**ARCHITECT'S SUPPLEMENTAL INSTRUCTIONS**

PROJECT: Lee Lofts III  
Historic Rehabilitation & New Apartments  
Salina, KS Report No. Two (2)

CONTRACTOR: MCP Group  
3501 SW Fairlawn Rd.  
Topeka, KS 66614 Architect's Proj No. 22-3243

DESCRIPTION:

**A** 1ST LEVEL FLOOR PLAN  
1/4"=1'-0" 6,802 sf

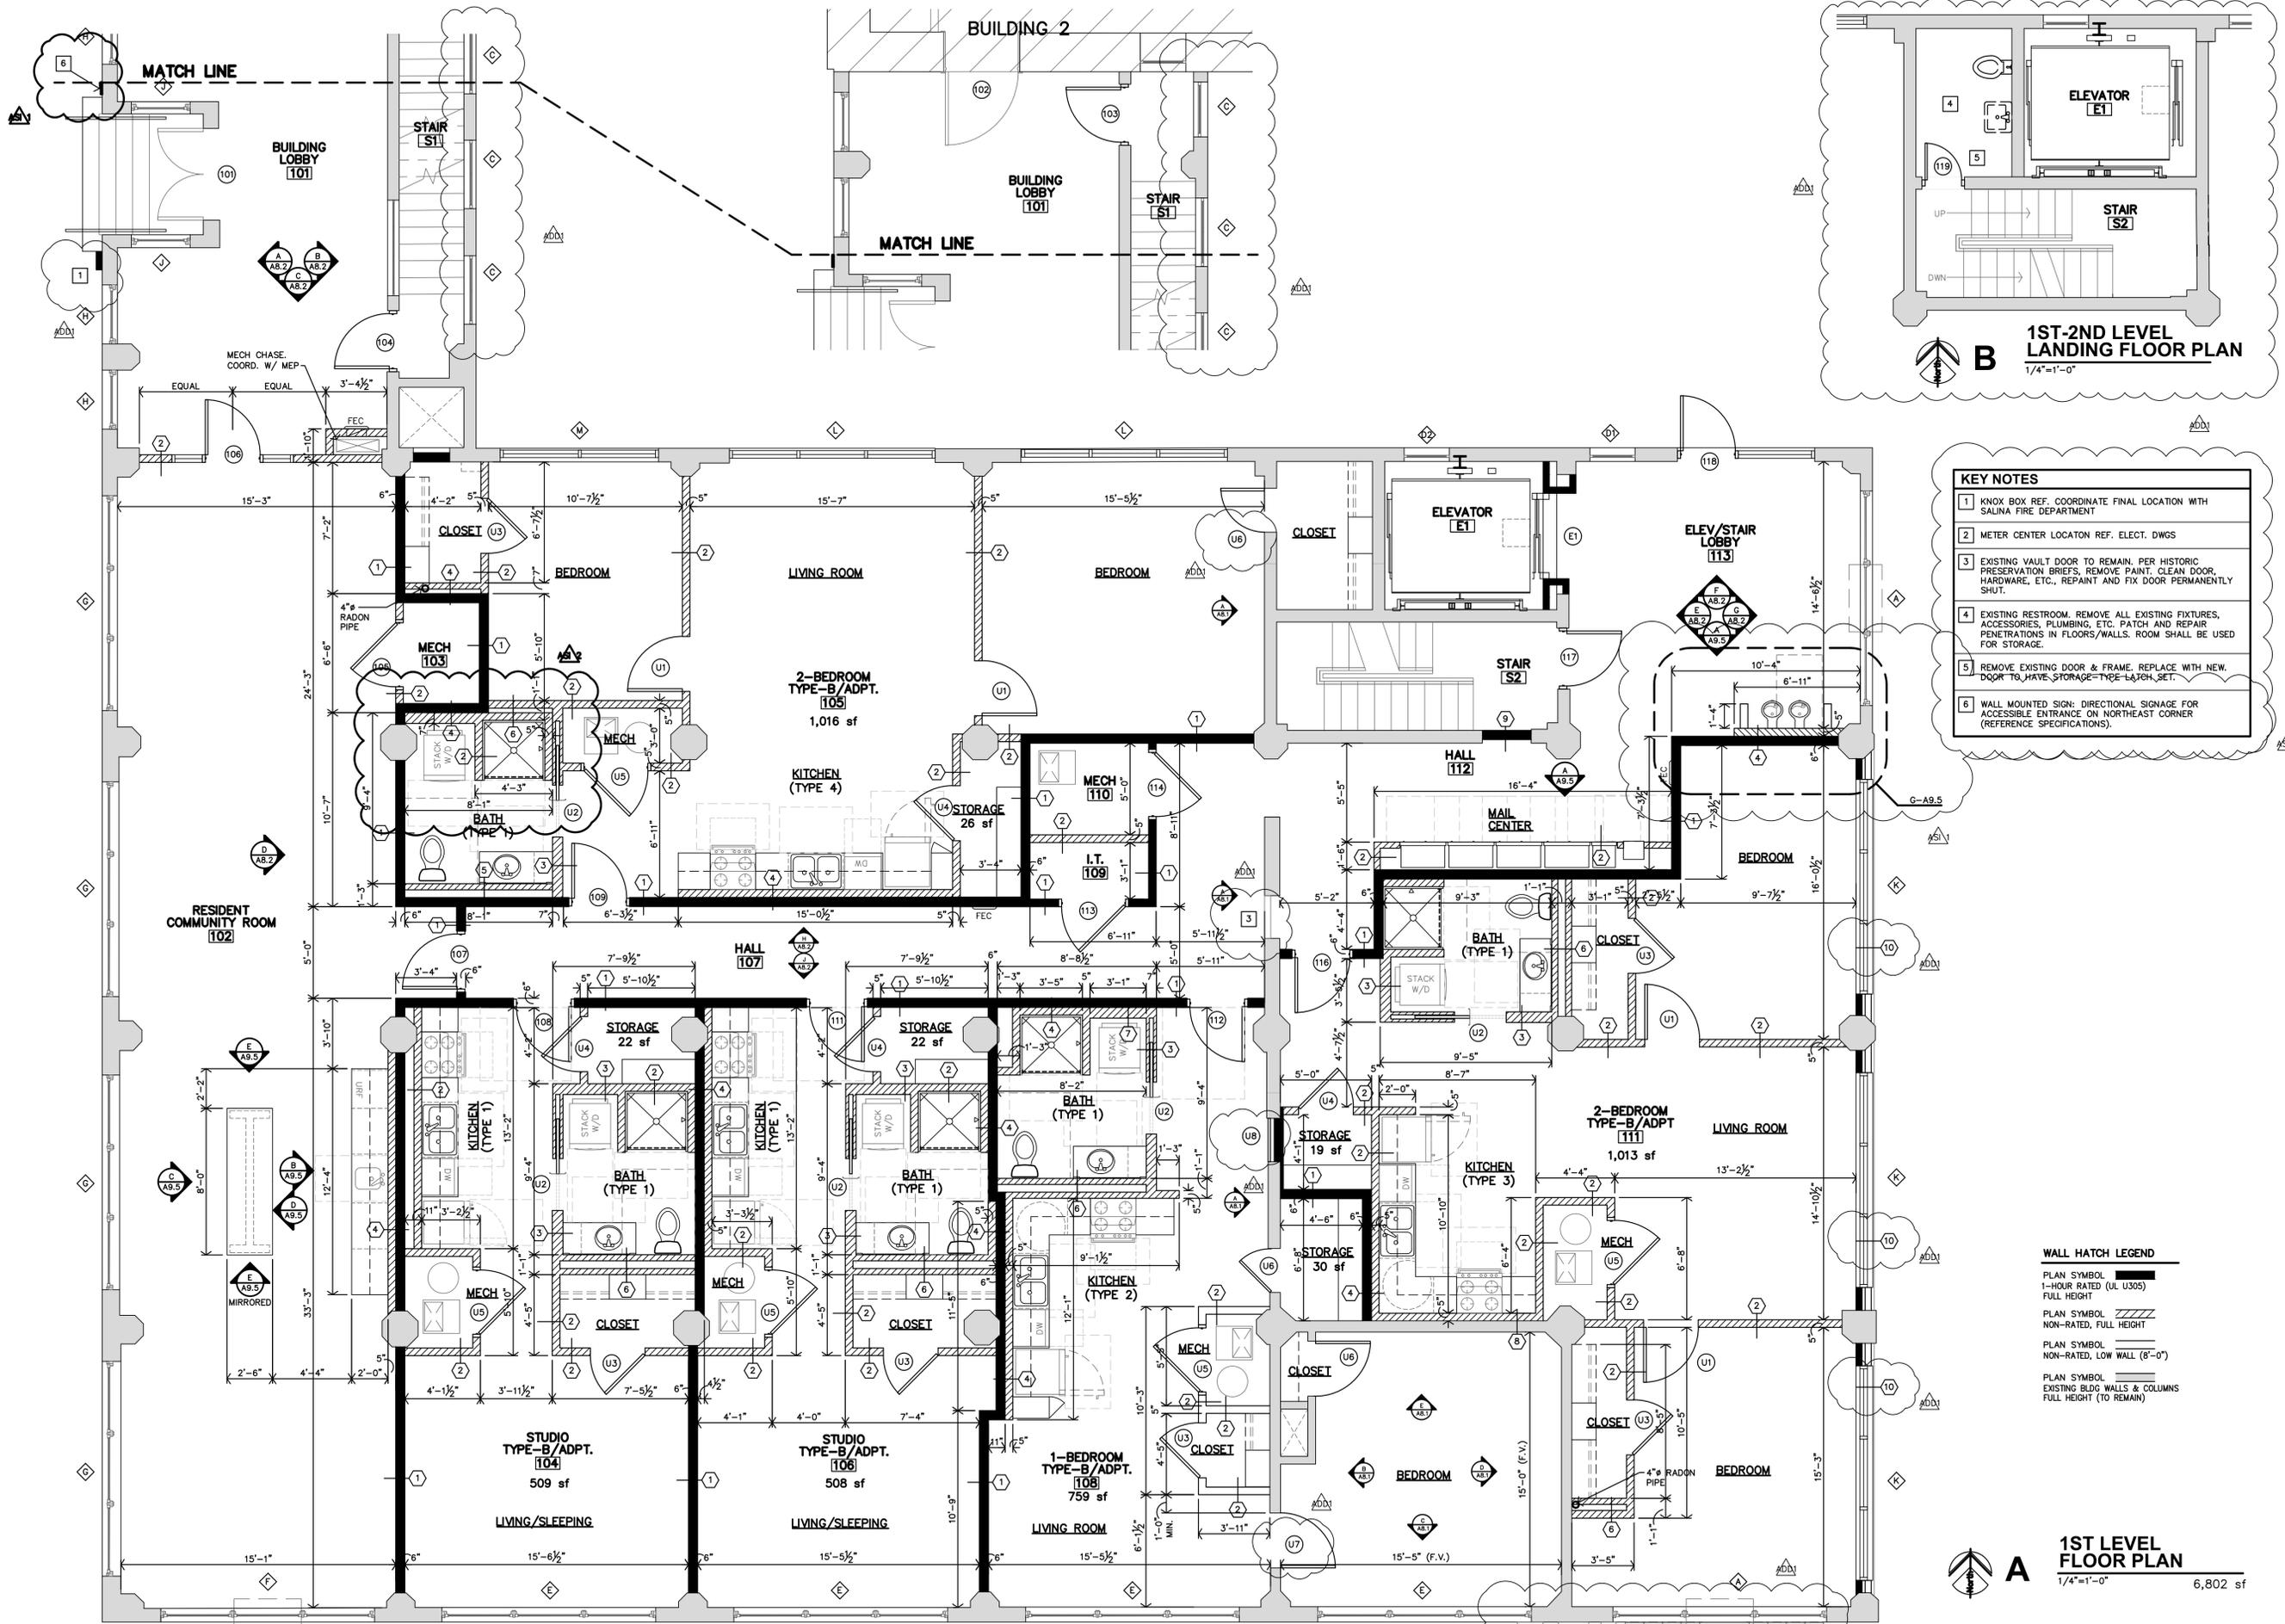
- a. Unit 105 – Mirrored Laundry and Shower. Added furred wall next to pocket door for plumbing
  - b. Units 208, 308, 408, 508 – Mirrored laundry and shower. Added furred wall next to pocket door for plumbing. Widened entire bath (and closet below) by 6". Shifted toilet and vanity wall north by 4"

**2ND LEVEL FLOOR PLAN**  
 1/4"=1'-0" 6,856 sf

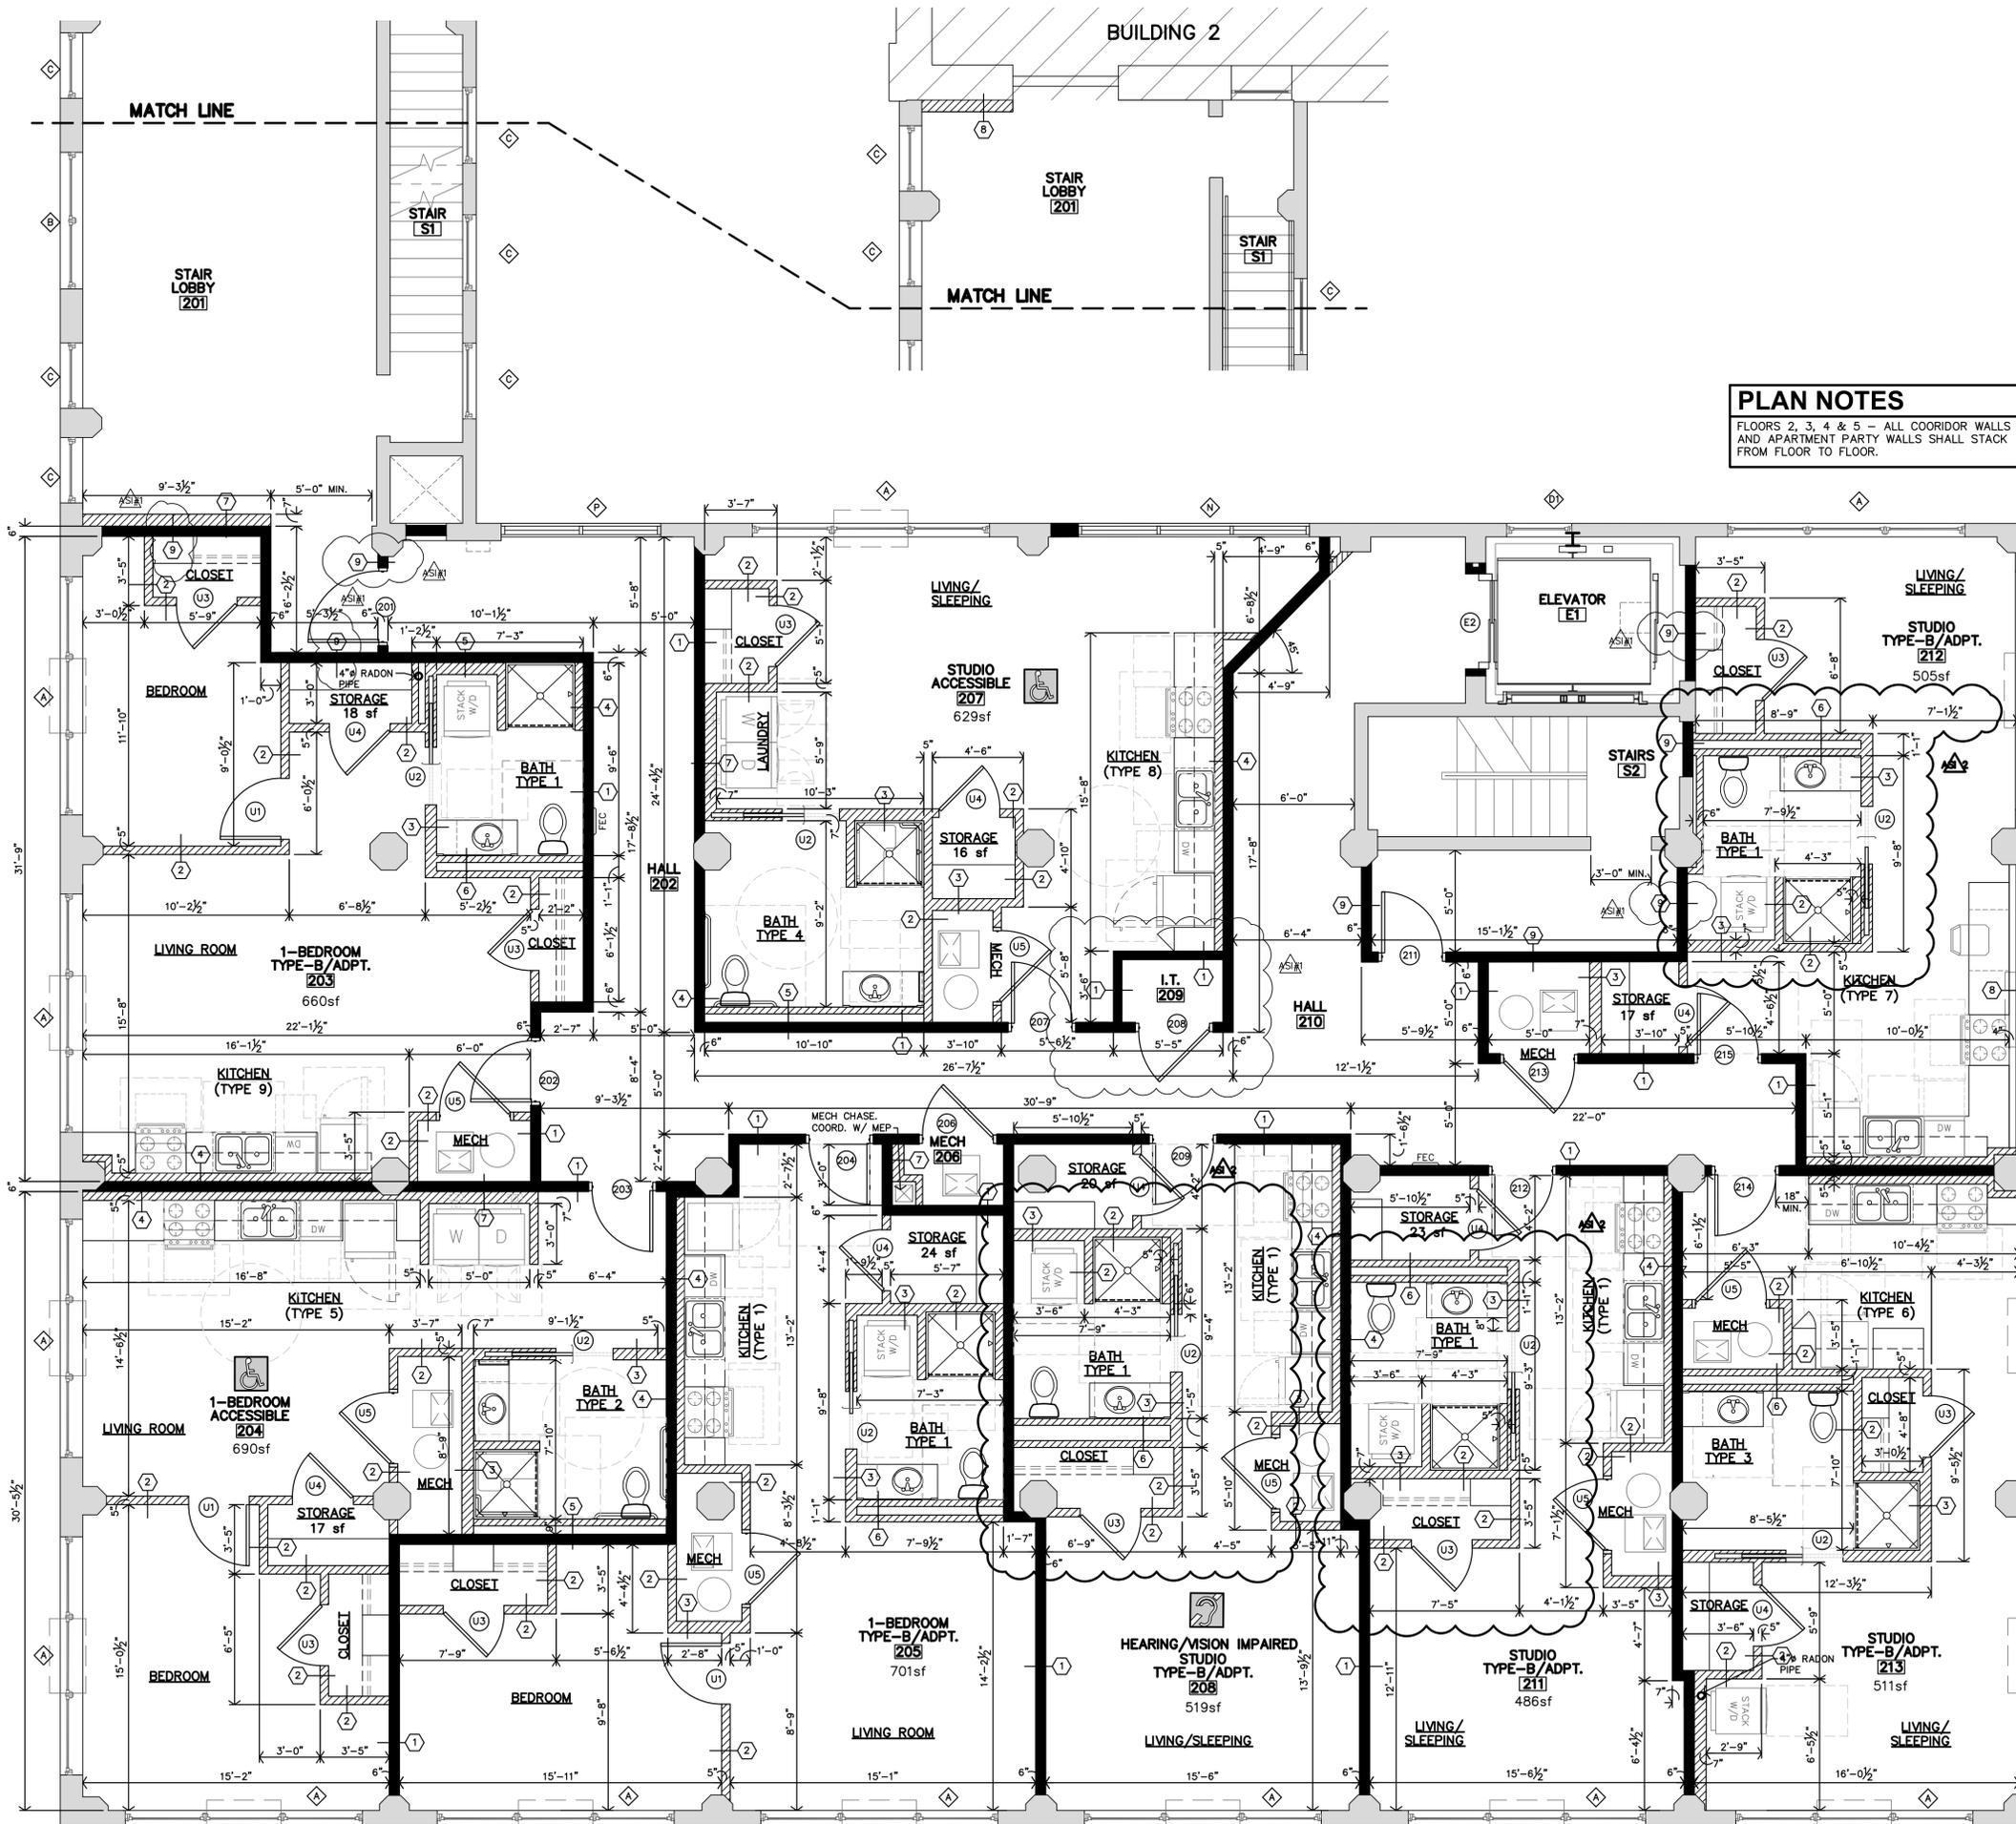
- c. Units 211, 311, 411 & 511 – Mirrored entire bathroom and plumbing chase, so toilet and vanity are on north end. Mirrored Laundry and shower. Added furred wall next to pocket door for plumbing. Widened entire bath (and closet below) by 6"

- d. Units 212, 312, 412 & 512 – mirrored laundry and shower. Added furred wall next to pocket door for plumbing. Widened entire bath (and closet below) by 6"
